**RE: Addendum to the Contract Documents for the West High Service Pump Station
Bid No. ITB-4221**

**ADDENDUM NO. 2
TO
BID DOCUMENTS
FOR
WEST HIGH SERVICE PUMP STATION
FOR THE
CITY OF ANN ARBOR, MICHIGAN**

The following changes, additions, and/or deletions shall be made to the Bid Documents for the West High Service Pump Station Project for the City of Ann Arbor, Michigan, Bid No. ITB – 4221 on which bids were to be received, on or before, 10:00 A.M. Thursday, May 31, 2012.

C-104

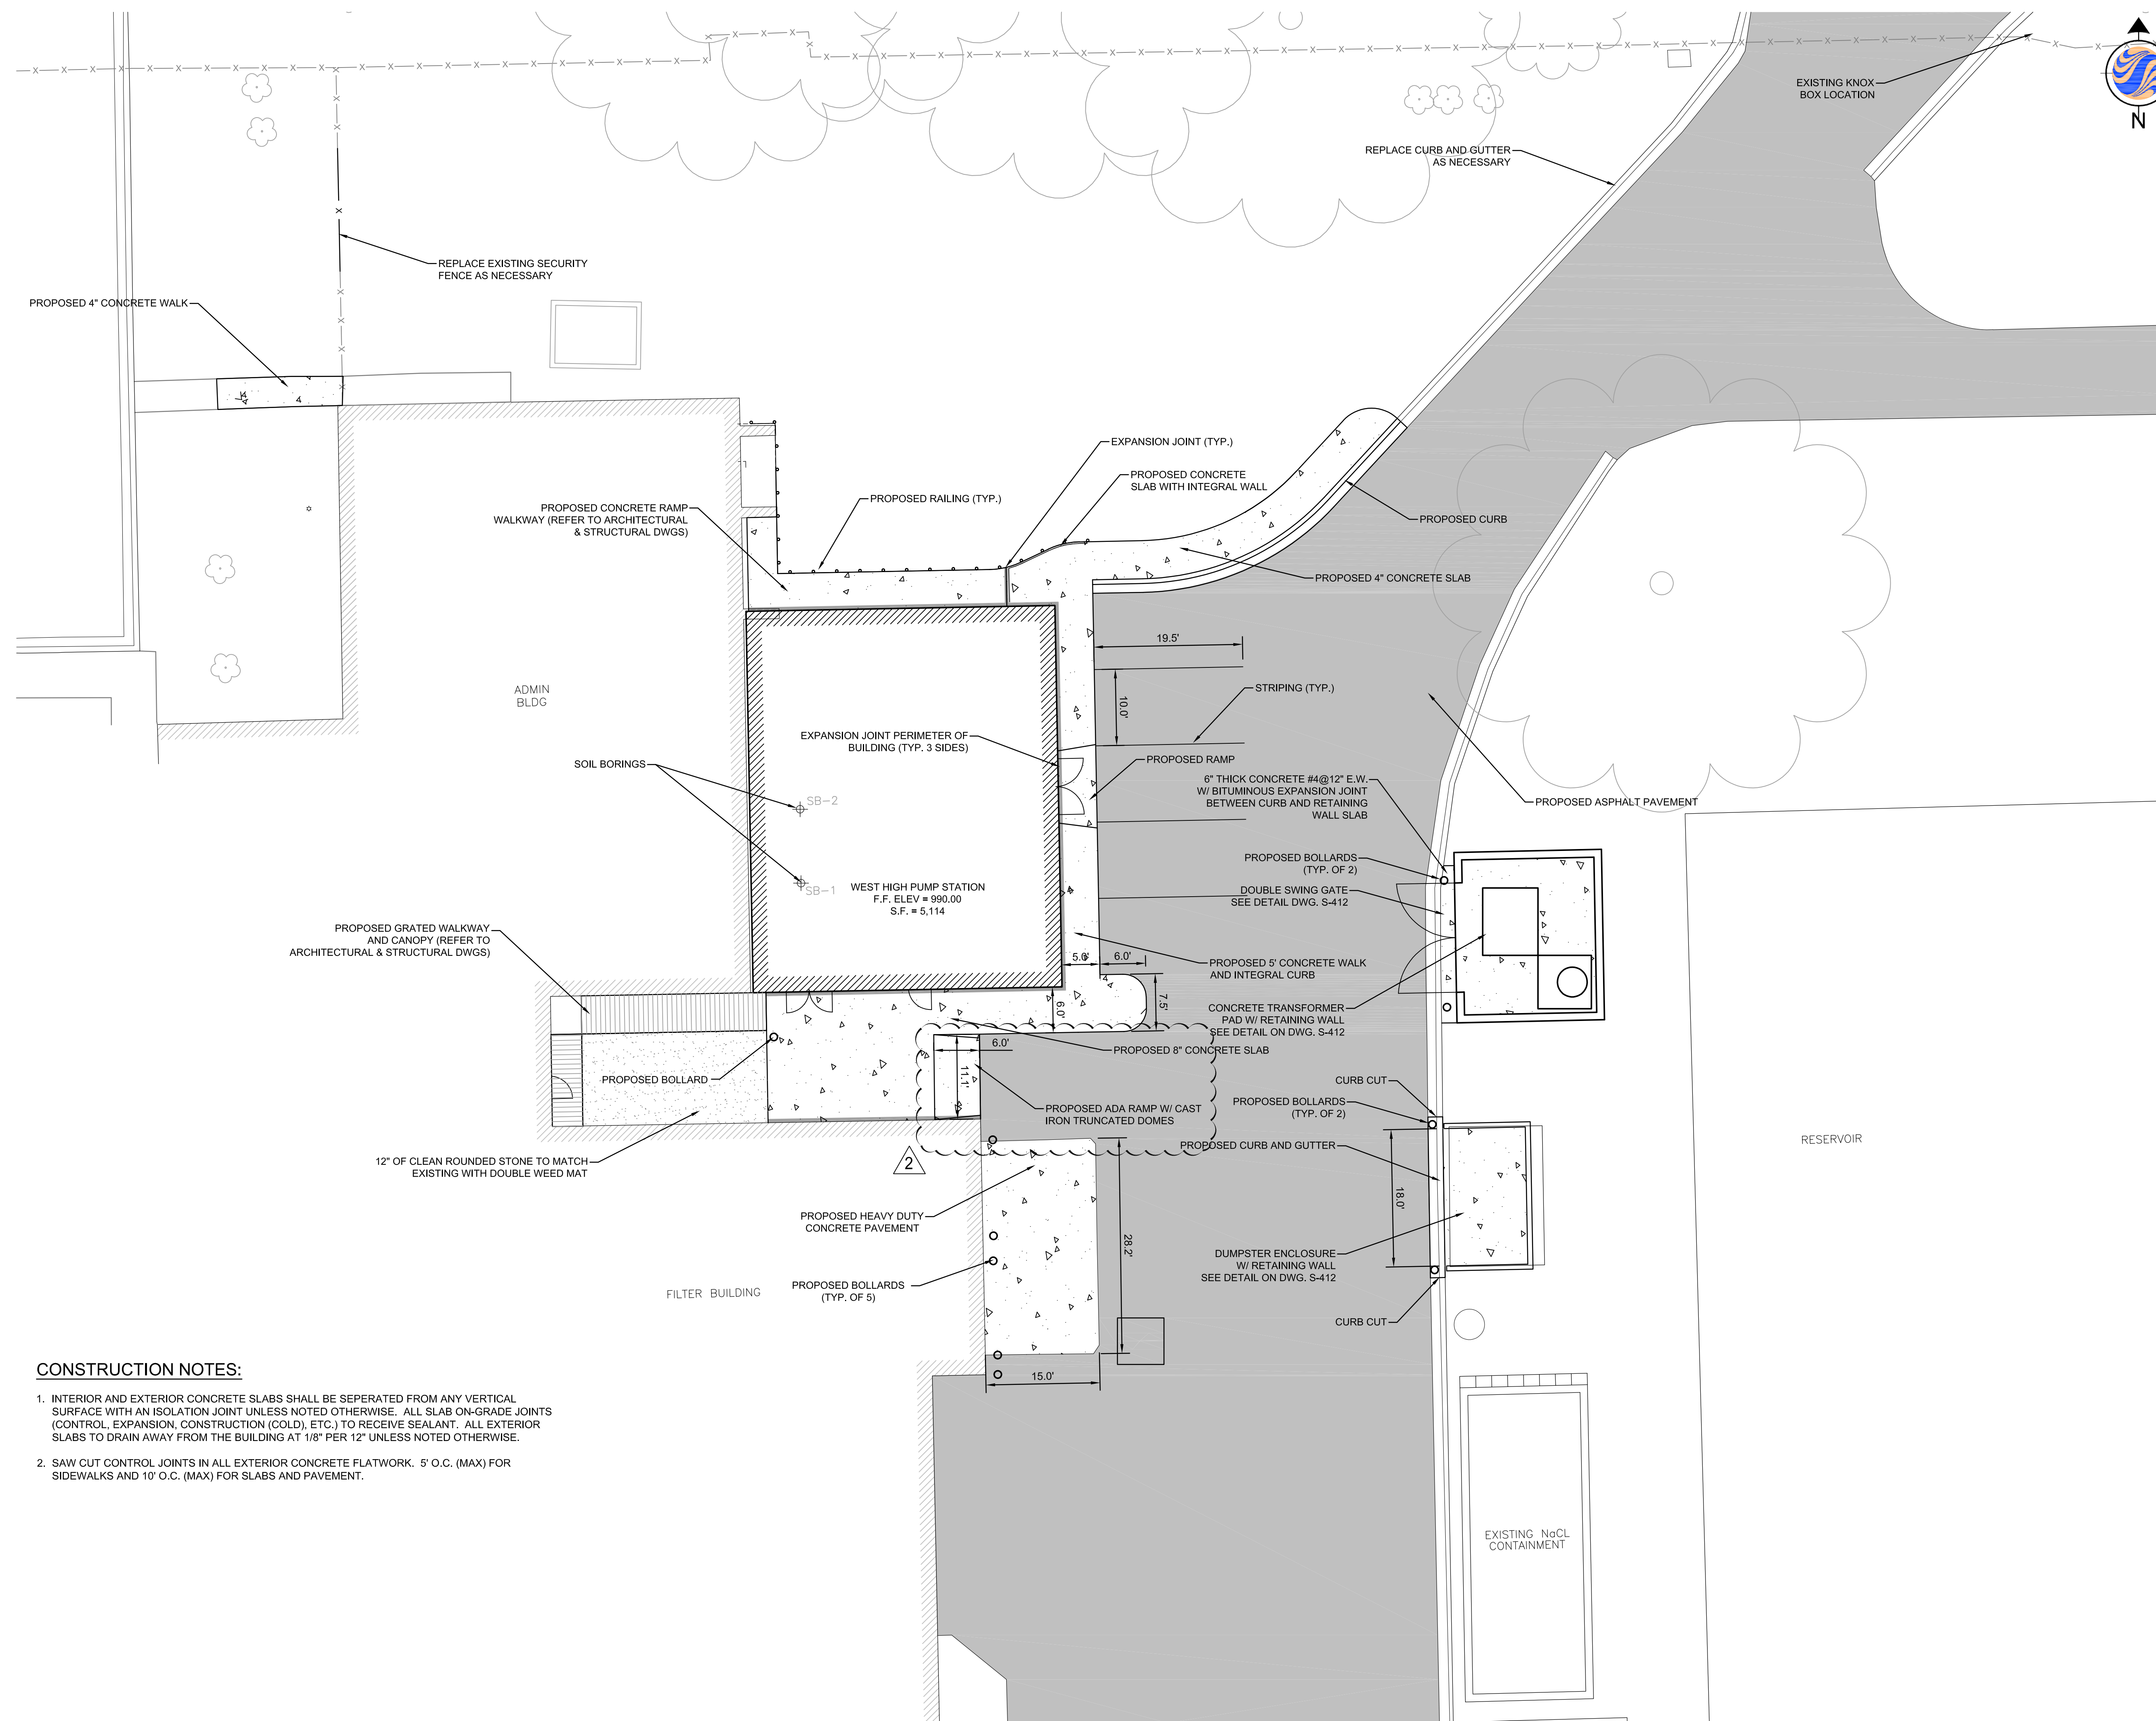
Revise Drawing C-104 to reflect an ADA compliant ramp on the south side of the pump station.

1 PROCESS FLOW DIAGRAM
 P-102 N.T.S.

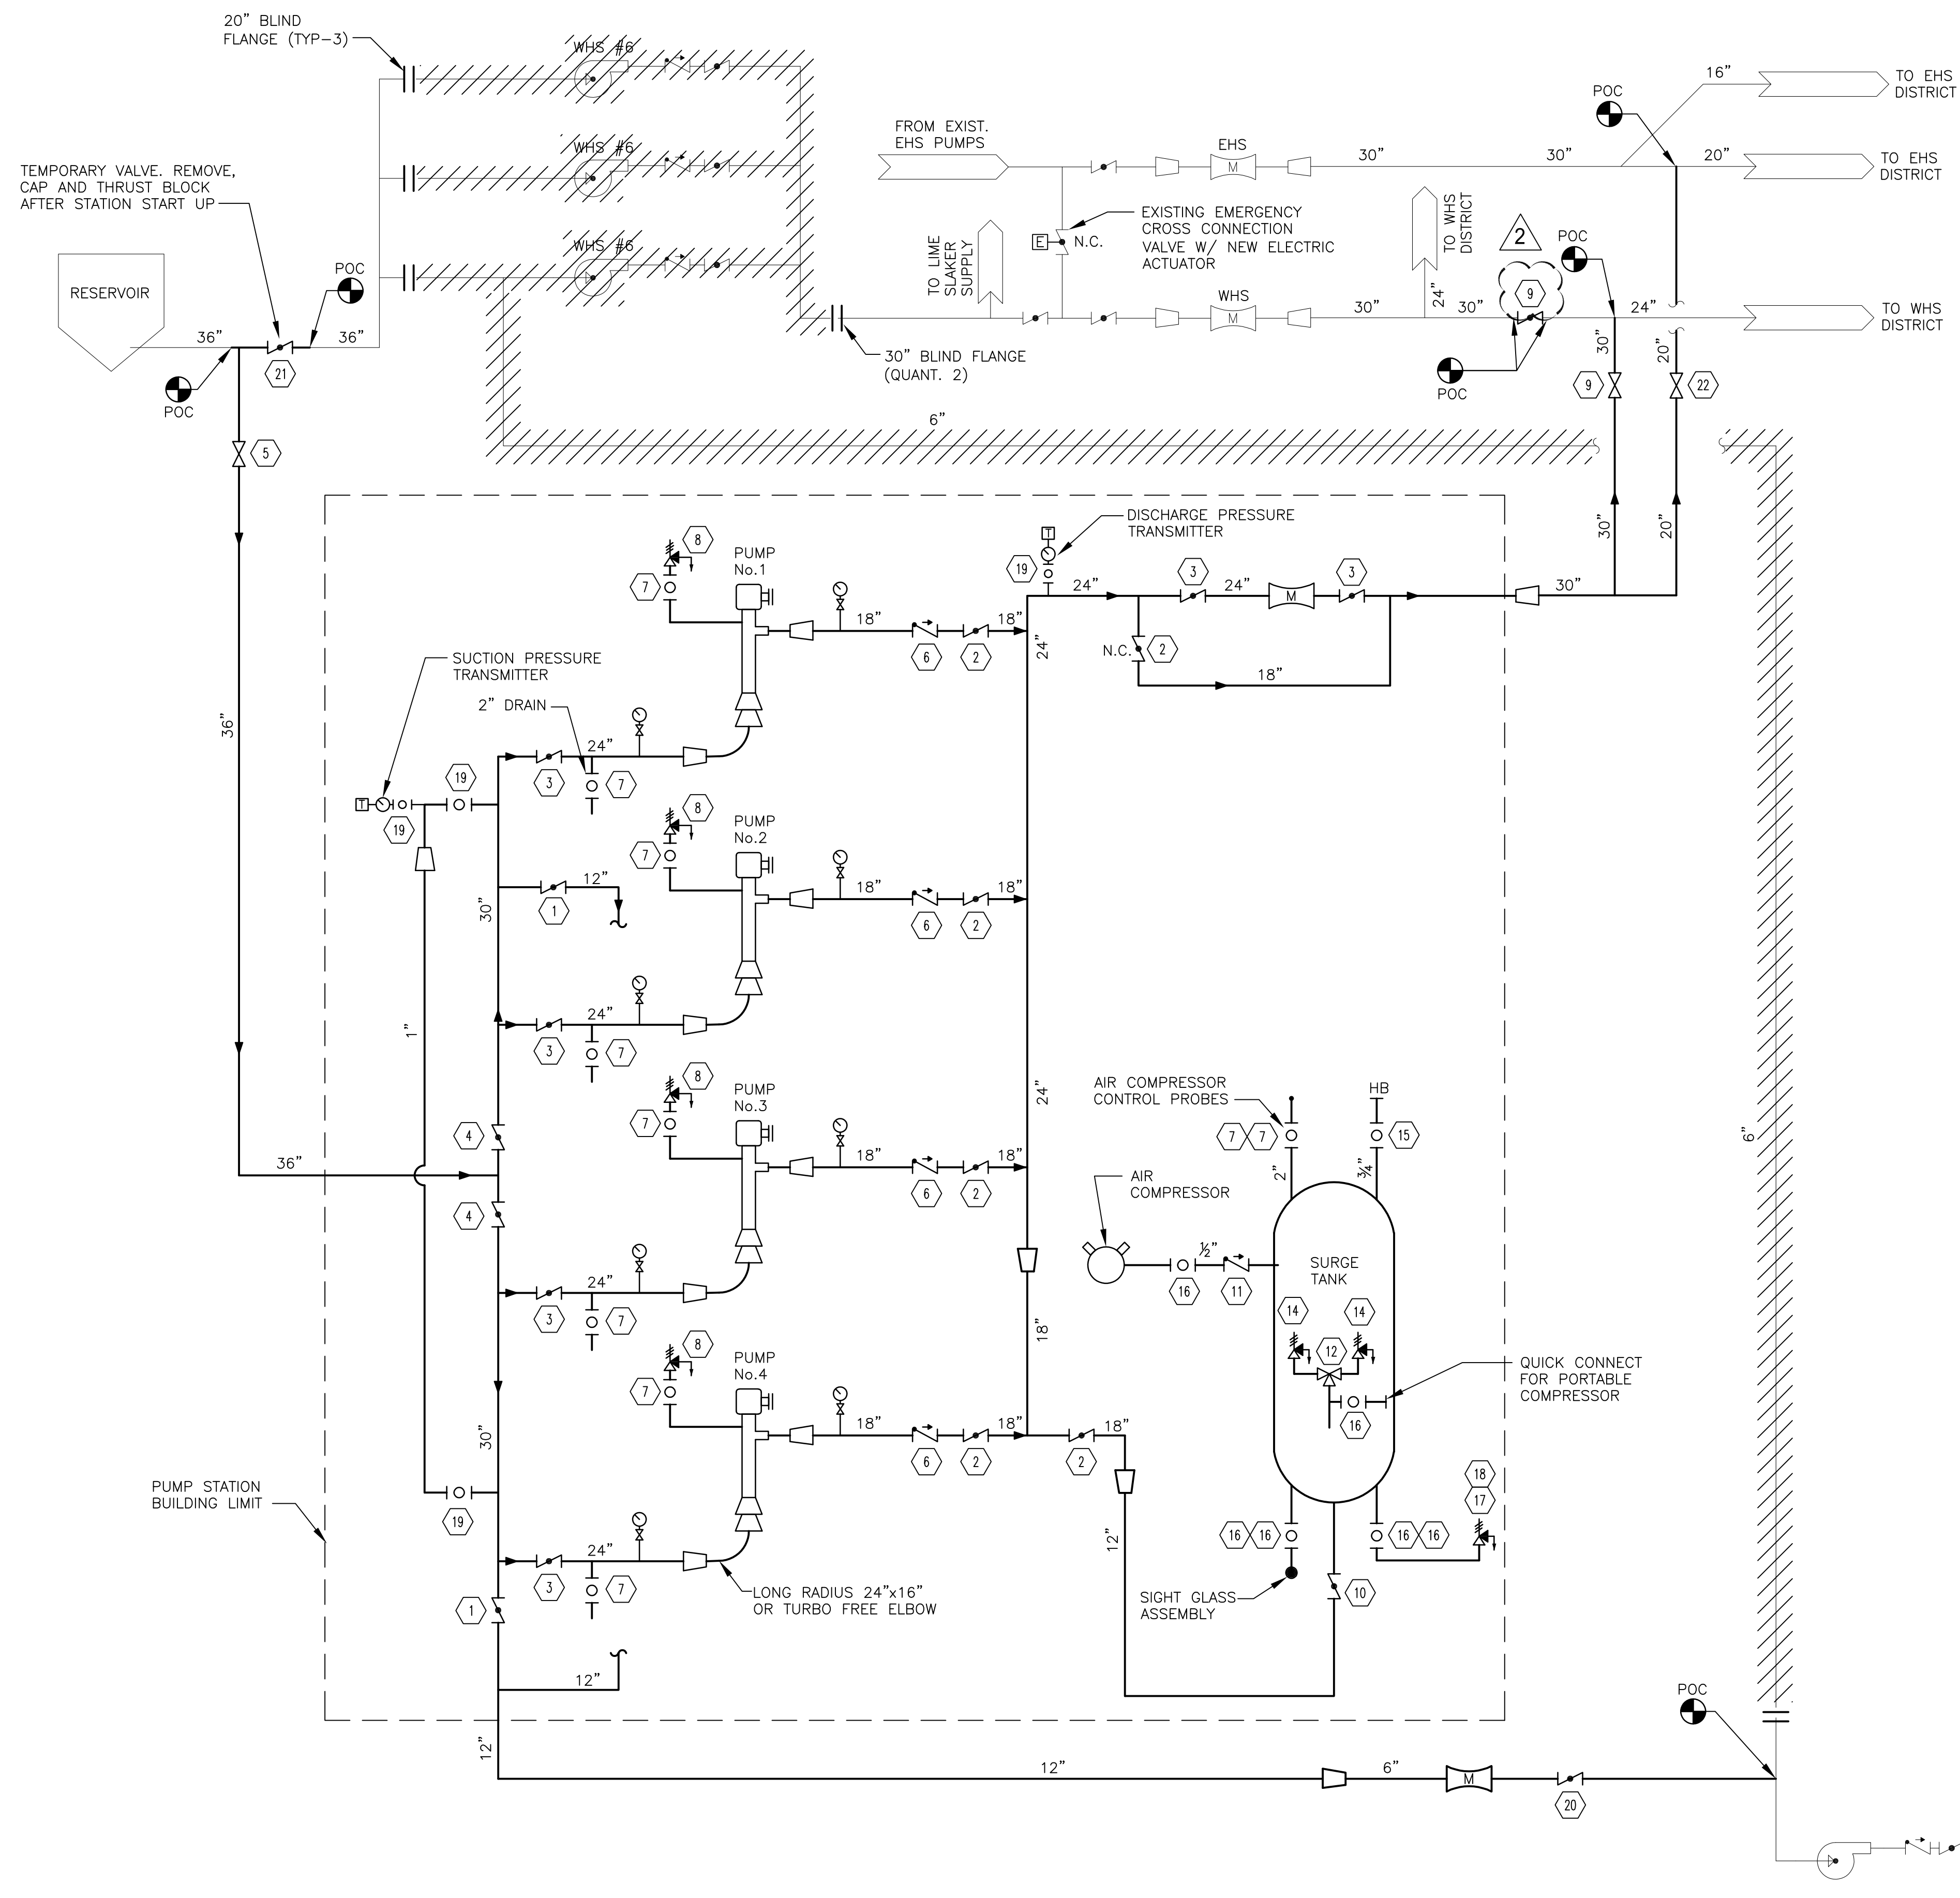
Revise Drawing P-102 to reflect the valve type change on the WHS discharge.

- Q. On Drawing P-102 in the Valve Schedule, please clarify the comment in the Valve ID column.
- A. **All valves and tags shall be provided by the Contractor. Only the number scheme for identification shall be provided by the Owner/Engineer.**
